TOWN OF WELLS, MAINE
PLANNING BOARD

Meeting Agenda
Monday, February 23, 2026, 7:00 PM
Littlefield Meeting Room, Town Hall
208 Sanford Road

VI. **526 POST ROAD**

Sheet No.: C2.0

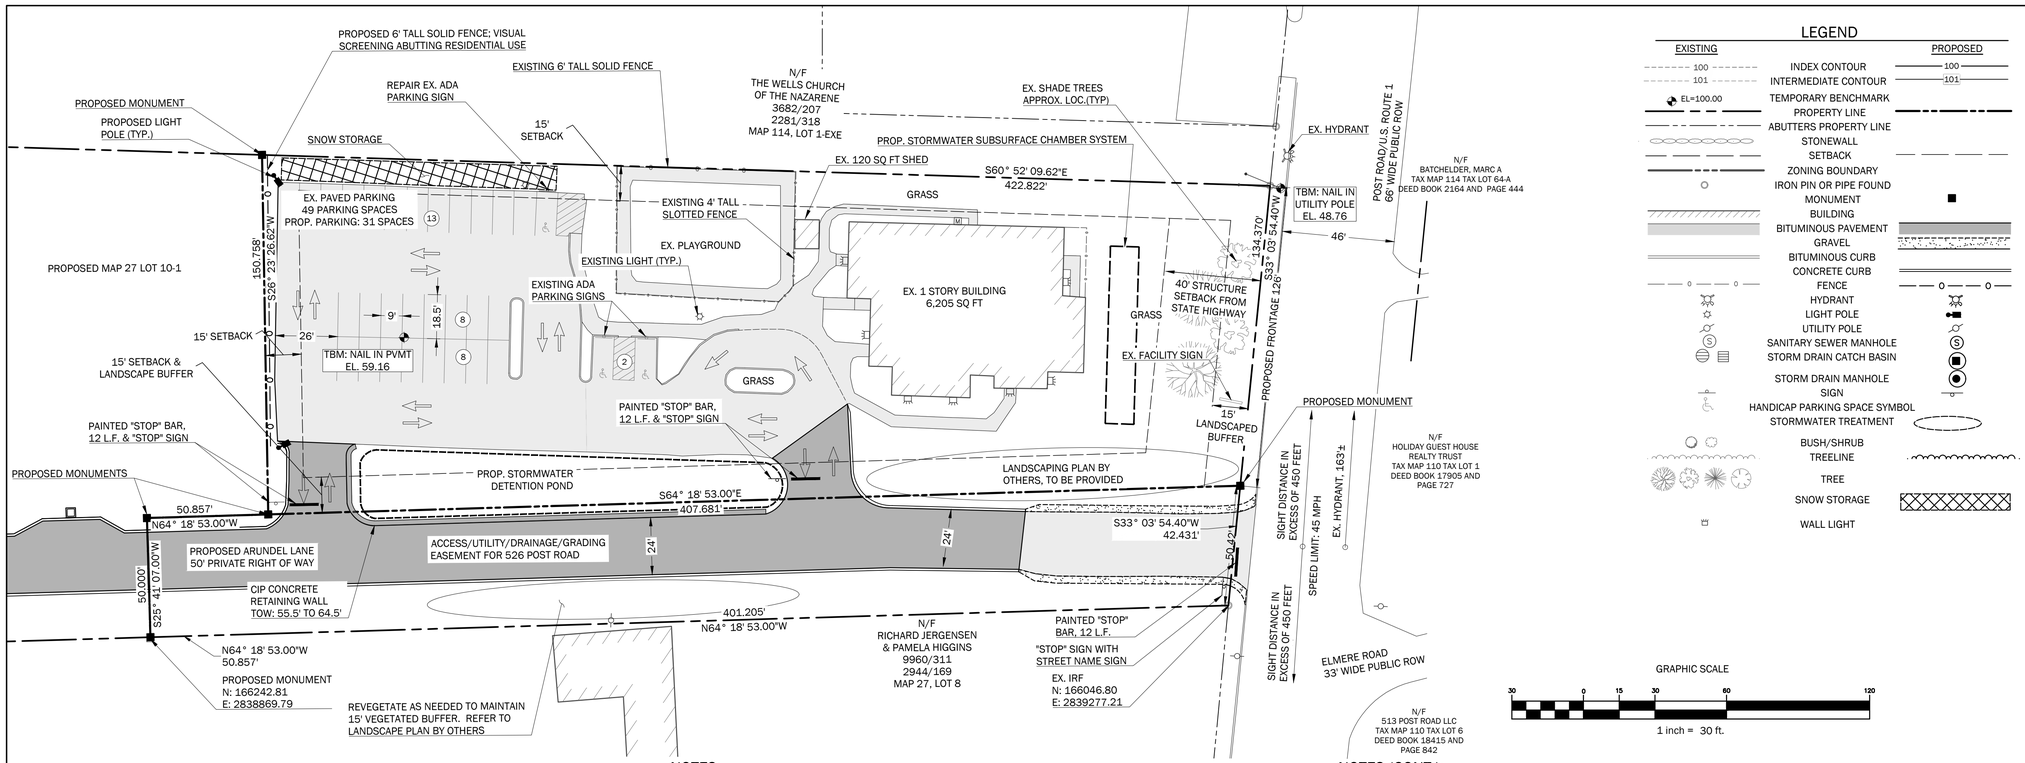
A.(4)	All existing and proposed setback dimensions	15' lot line setbacks shown. 40' lot line setback from Route One shown. **25' lot line setback from Arundel Lane ROW proposed, Per 145-35.O this 25' setback can be reduced to 15'.**	Y	C2.0	The setback off of the proposed lot line abutting the Arundel Lane R.O.W. has been reduced to 15' in the updated design plans included herein.

ITEM NUMBER	DESCRIPTION	STAFF COMMENT 1/23/2026	COMMENT ADDRESSED	DRAWING / SHEET NUMBER	COMMENT RESPONSE 2/10/2026
A.(14)	The lot lines of all lots abutting the proposed development, including those lots across the street, together with the names on file in the Town offices as of the date of the application	All abutters are identified, except proposed Map 127, Lot 10-1	Y	C2.0	Proposed lot 10-1 has been identified on C2.0 - Site Plan.

Sheet No.: C2.0

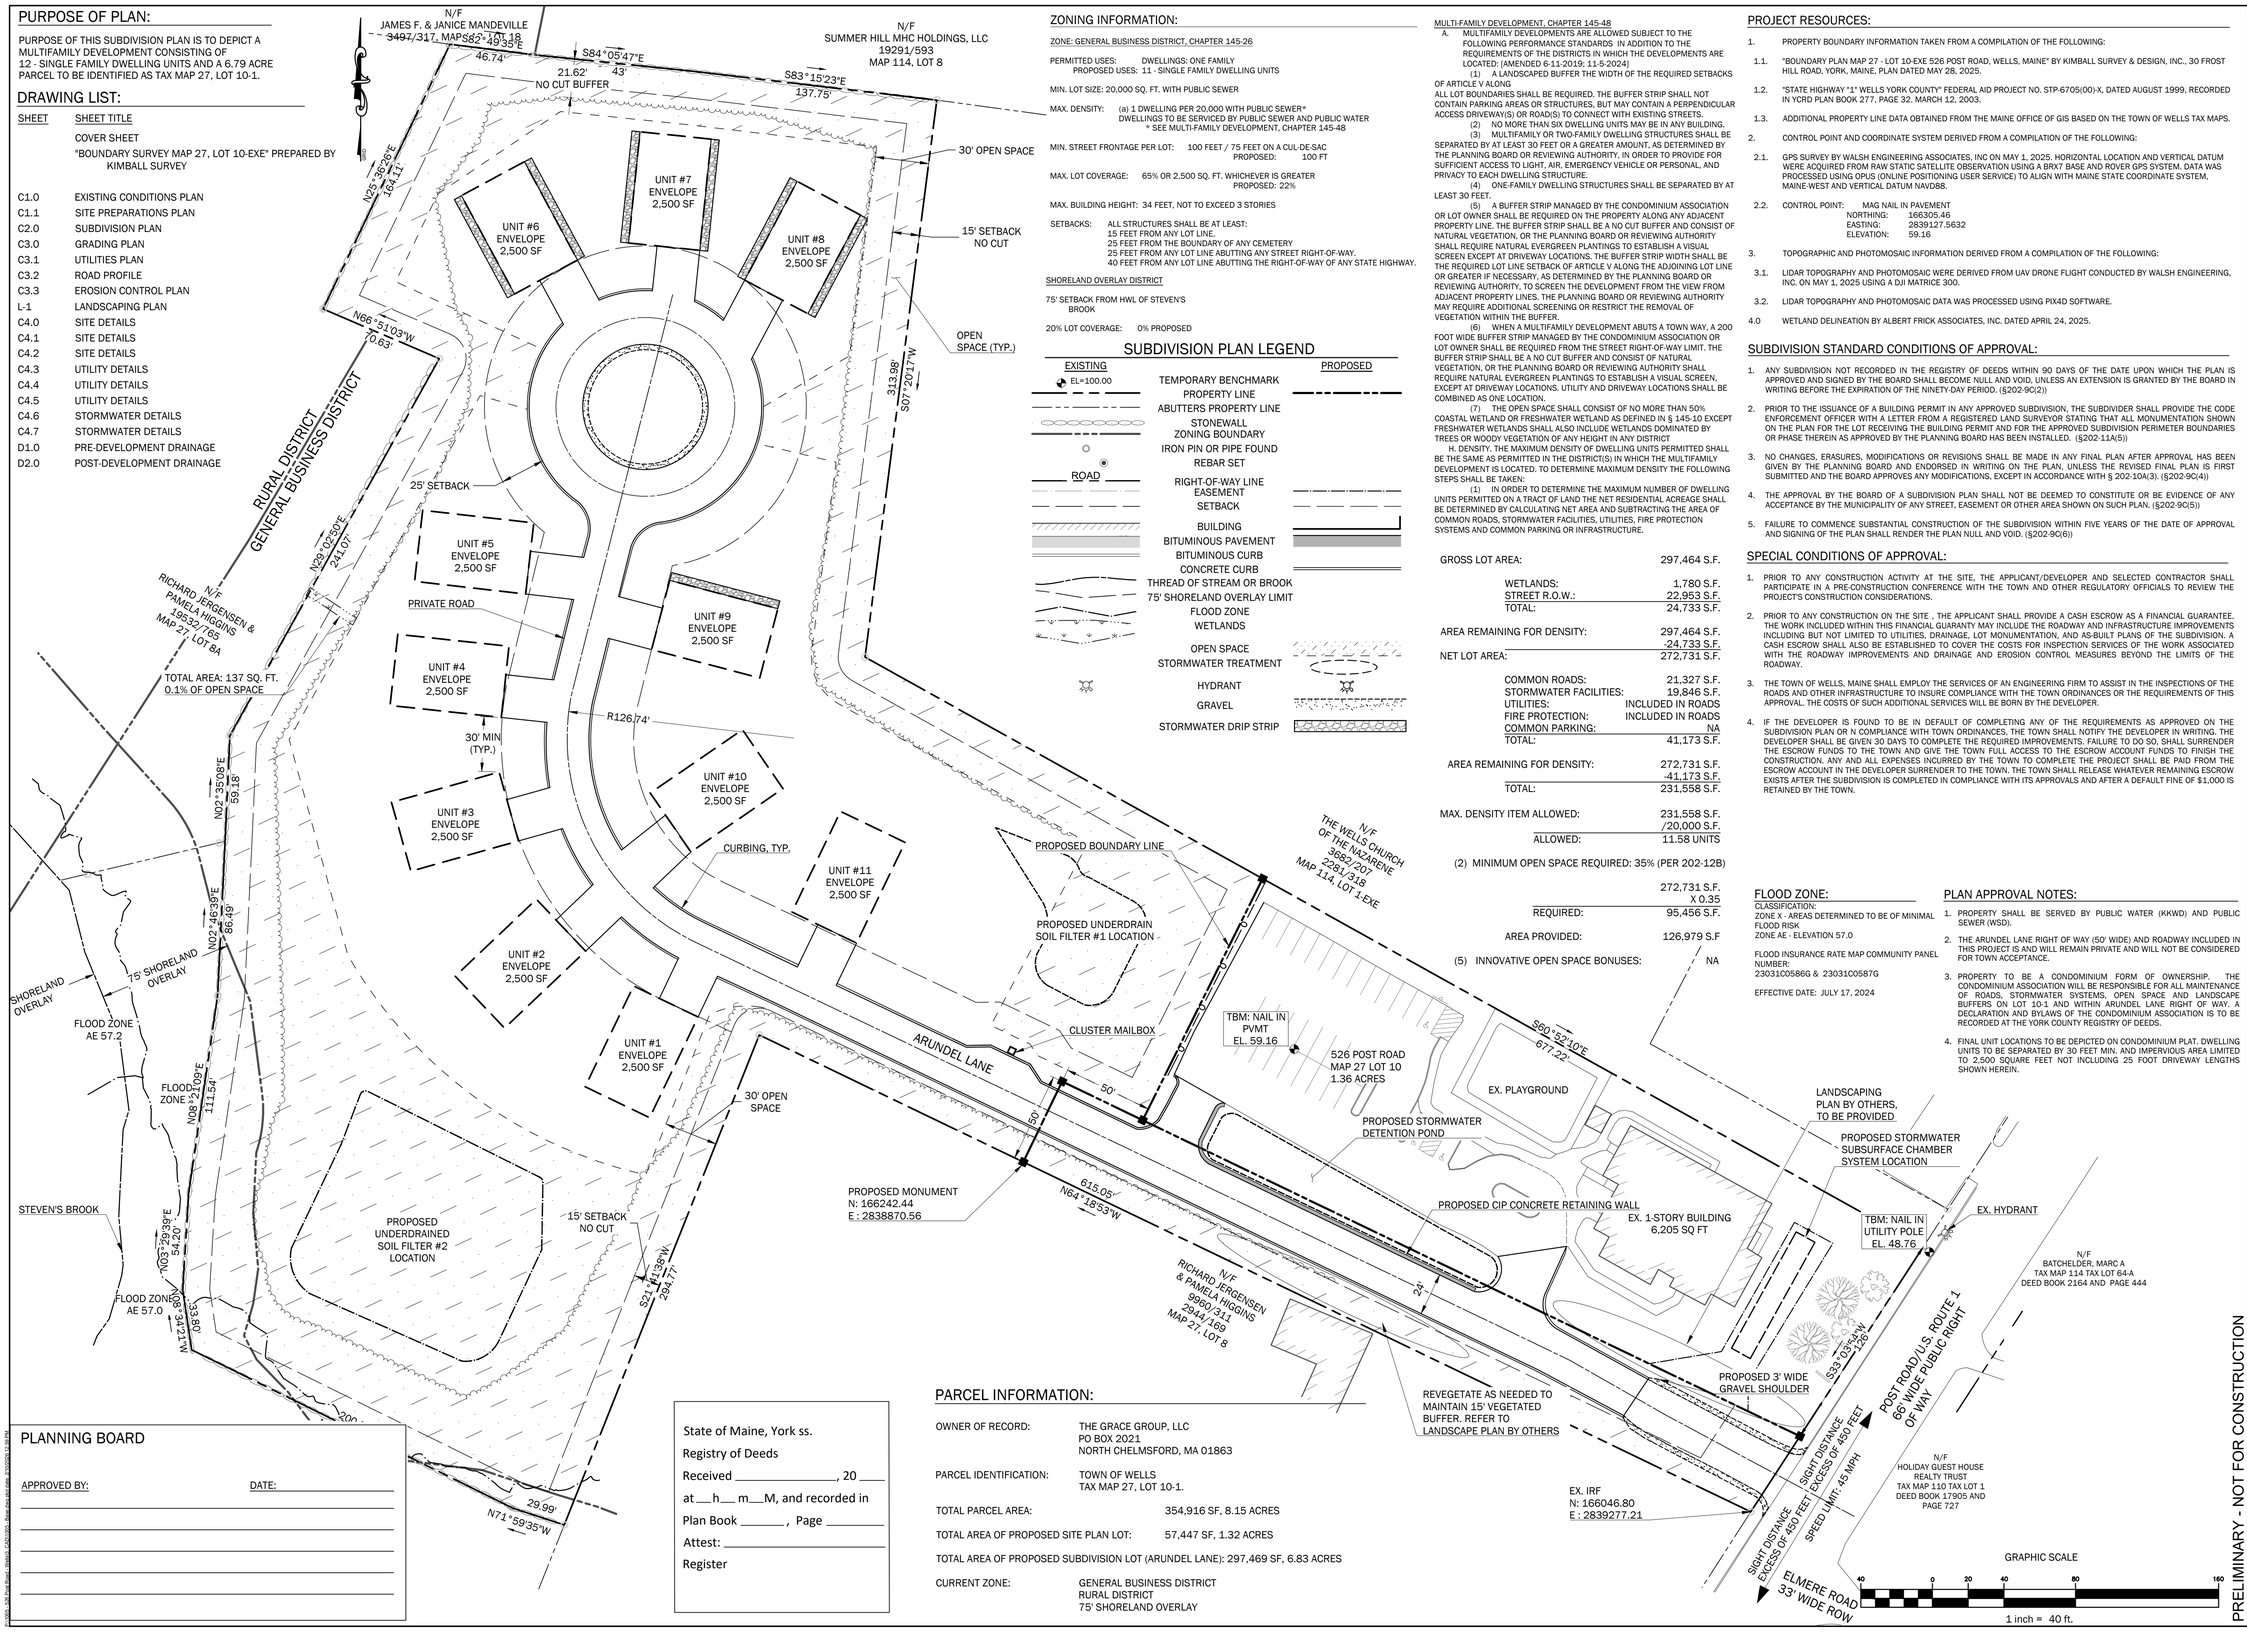
xiv. Are the 2,500 square feet boxes on the plan building envelopes or exact building footprints? Will decks, porches, patios, generators, sheds, fire pits, HVAC units, etc. be allowed for each unit? If so, lot coverage to facture. The 2,500-square-foot boxes shown on the plans represent approximate building envelopes that cap the building, deck, porch, generator, HVAC, and other impervious features at 2,500 square feet per unit. Lot-coverage calculations are based on this maximum; actual as-built coverage may be less but will not exceed the 2,500-square-foot allowance shown on plan C2.0.

F.(6).a. [3]	Twenty-five feet from any lot line abutting any street right-of-way.	**Parcel does abut the Arundel Lane ROW. 25' setback to be identified.**	Y	C2.0	Proposed 25' setback off of Arundel Lane ROW has been added.
145-48	**PERFORMANCE STANDARDS - MULTIFAMILY DEVELOPMENTS**				
A.(1)	A landscaped buffer the width of the required setbacks of Article V along all lot boundaries shall be required. The buffer strip shall not contain parking areas or structures, but may contain a perpendicular access driveway(s) or road(s) to connect with existing streets	15' wide landscaped buffer along all lot lines noted. **Label corrections needed.** Arundel Lane roadway serving the multifamily development crosses the buffer required from the street ROW.	Y	All Sheets	Labels for the proposed 15' landscaped buffers for the multifamily development have been updated accordingly on all sheets.
A.(4)	One-family dwelling structures shall be separated by at least 30 feet.	**Single family dwellings shall be separated by a minimum of 30 feet. Measurements between the units on the plan appear to be 28 or 29', not 30'.** **Plan provided is not to scale.**	Y	All Sheets	Confirmation that all building envelopes are separated by 30 feet. Plans have been printed with correct margins to provide accurate scale.

SHEET C-103

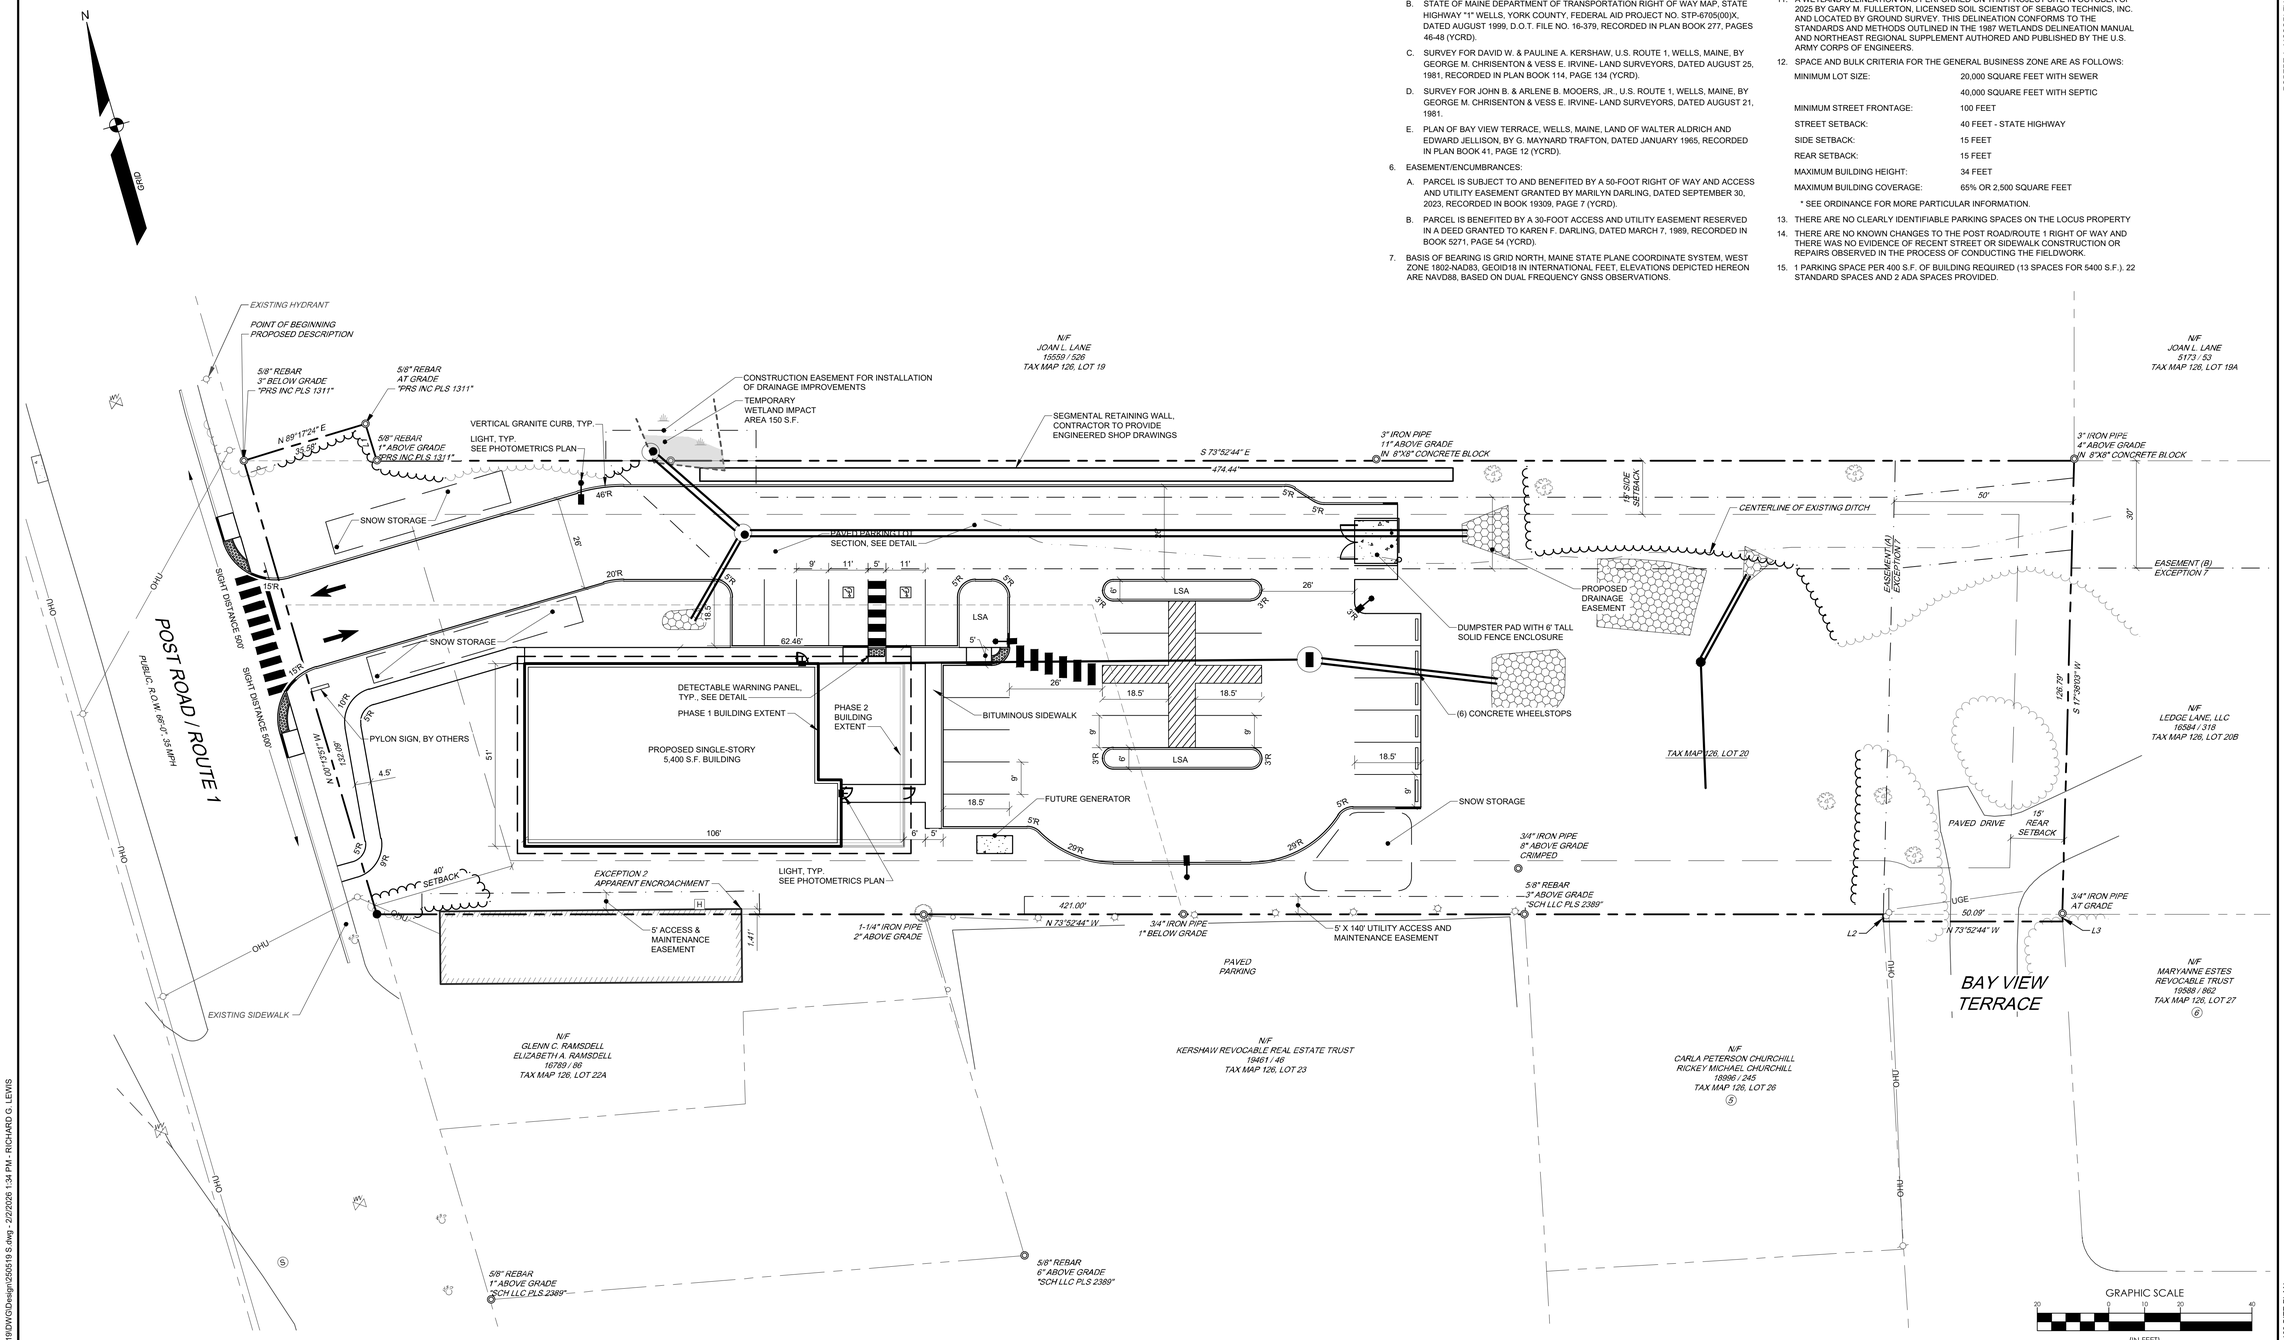
(5)	The size, location, direction and intensity of illumination of all major outdoor lighting apparatus and signs.	**Y**				Proposed exterior building mounted lights and light poles are identified. **Light and glare note to be added to sheet C-101.** Photometric plan provided. No impacts to be abutters.
